ASSESSMENT REPORT

Block 11 - Central Park, Chippendale SSD 6376 MOD 2

Figure 5: Approved (top) and modified (bottom) southern elevation fronting Wellington Street (Base source: Applicant's EIS)

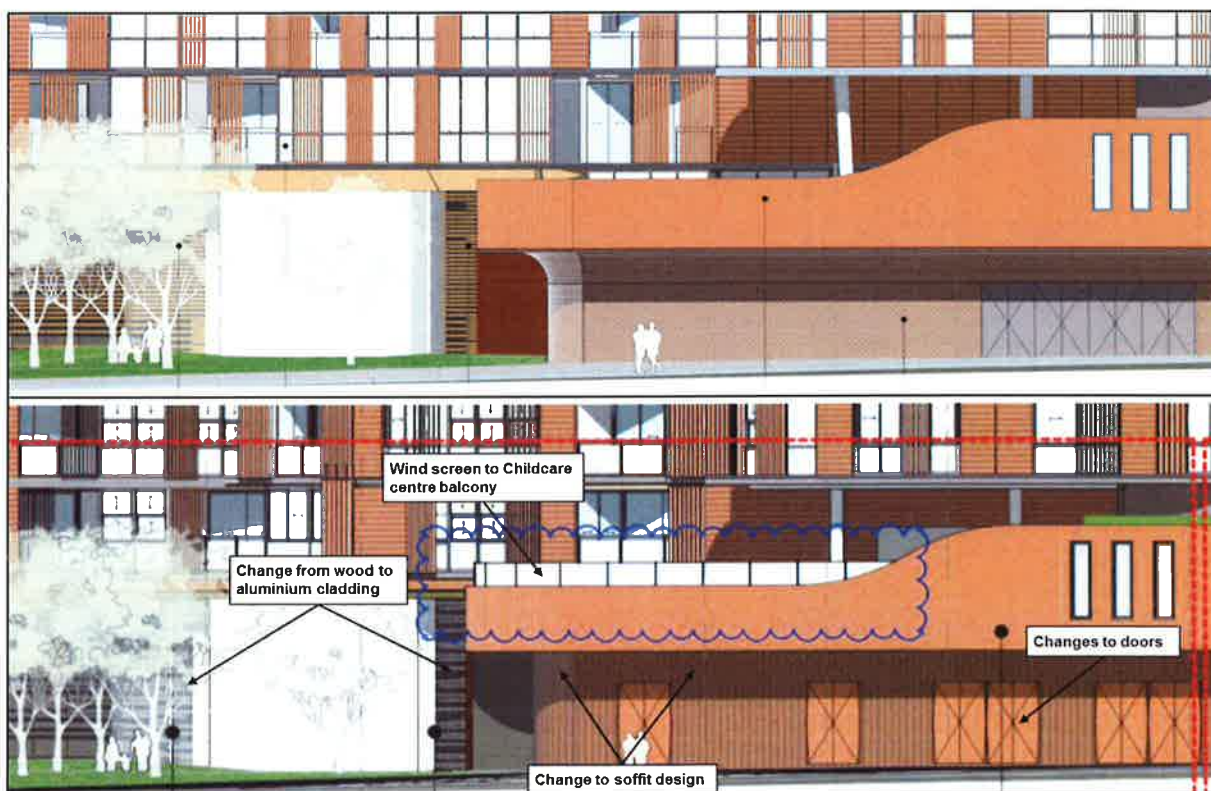
- additional changes are included on the plans and elevations not listed in the application, including changes to, and insertion of more windows, deletion of fins to balconies and provision of additional apartments on Level 7
- the soffit below the outdoor childcare space fronting Wellington Street should be light in colour and include appropriate lighting
- lowering building costs is not a valid reason to reduce the design excellence of the development
- clarification is needed of the proposed changes to materials.

Figure 6: Hydrant booster location (Base source: Applicant's EIS)

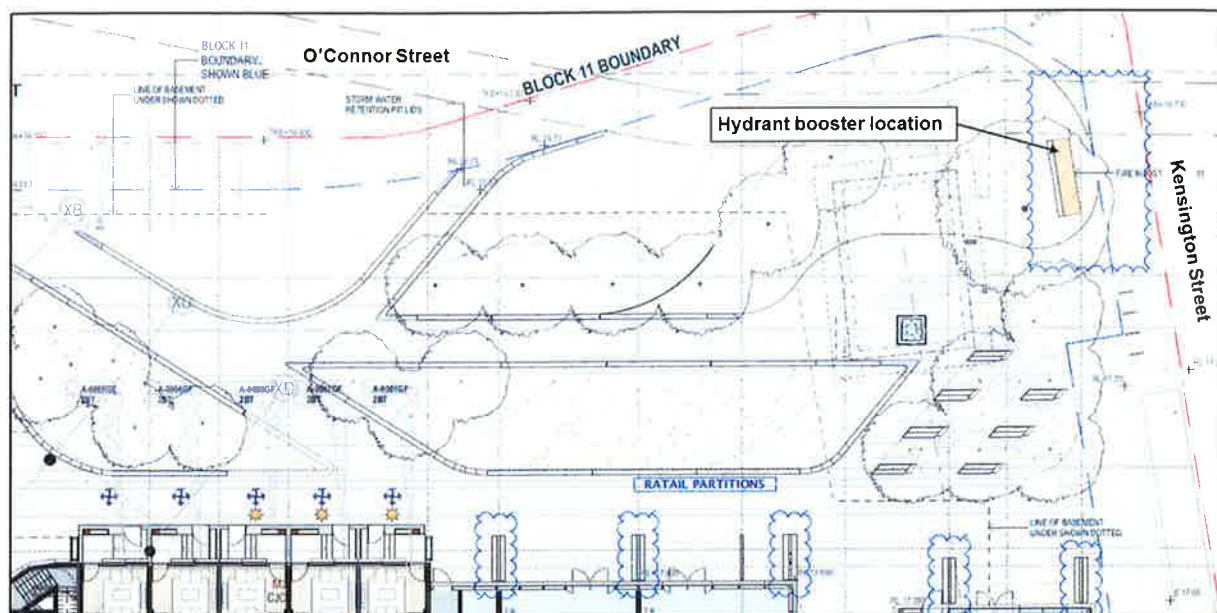
<i>Hydrant booster</i>	- The proposal includes the removal of the enclosure surrounding the approved hydrant booster, located within the O'Connor Street park (Figure 6). - The Department notes the removal of the enclosure would reduce the visual prominence of the booster. In addition, the booster would be surrounded by landscaping comprising mounding and screen planting. - The Department considers the removal of the booster enclosure would not have an adverse visual impact on the	No additional conditions or amendments necessary.

Figure 8: Deletion of the jacuzzi on Level 9 and reconfiguration of communal open space (Source: Applicant's EIS)

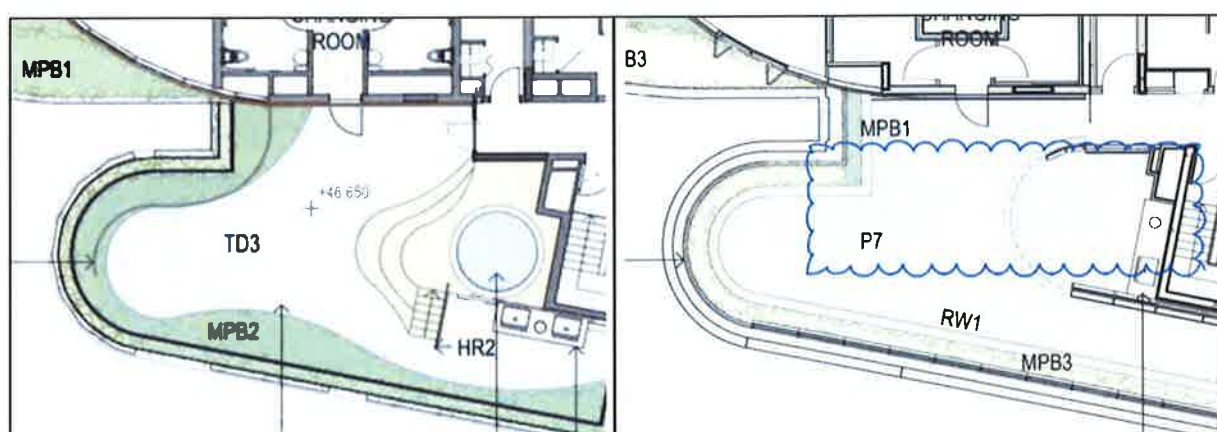
Other minor internal and external alterations	• The proposal includes the following internal and external alterations to the building: ◦ minor amendments to the building façades (including windows, doors and balconies) ◦ inclusion of CCTV ◦ reconfiguration of basement layout, including car parking, residential storage and lift access ◦ removal of the jacuzzi on Level 9 and reconfiguration of the communal open space at that level. • The amendments to the building façades result in very minor alterations to windows, doors and balconies. The Department considers those changes would not be discernible from the SSD Consent and are therefore acceptable. • The proposed CCTV has been provided in accordance with the recommendations of the SSD Consent Crime Prevention Through Environmental Design report and are therefore considered appropriate. • The reconfiguration of the basement level results in a minor rearrangement of car parking spaces, residential storage areas and stair/lift cores. The modification does not propose to change the total number of car spaces, residential storage or access to the basement levels. The Department considers those changes are acceptable. • The Department considers the removal of the jacuzzi on Level 9 is acceptable, and notes this results in a corresponding increase in communal passive open space for recreation.	No additional conditions or amendments necessary.
